Official Recall Notification U.S. Federal Boat Safety Act

Volkswagen Marine 3.0L TDI Tier II Ultraflex Control System Replacement and Turbocharger Oil Supply Line Sealing Washers

62628

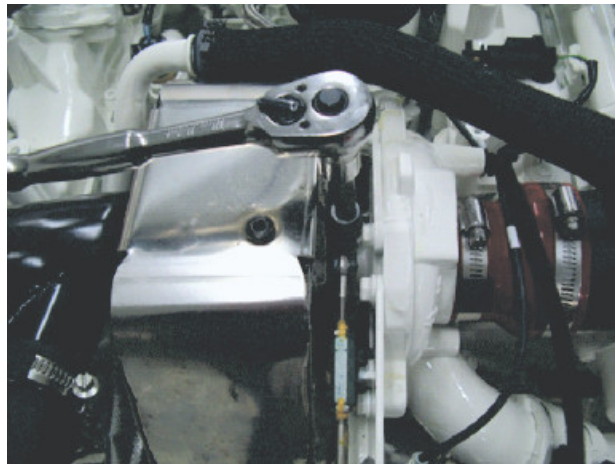
Engines that have the oil sealing washers reworked by the factory or by an authorized dealer will have a mark indicating that the rework has been performed. With the engine removed from the shipping container, or installed in a boat, the rework identification will be a yellow dot placed to the left of the serial number decal.

- Affix a yellow dot next to the serial number decal to indicate that the rework has been performed.
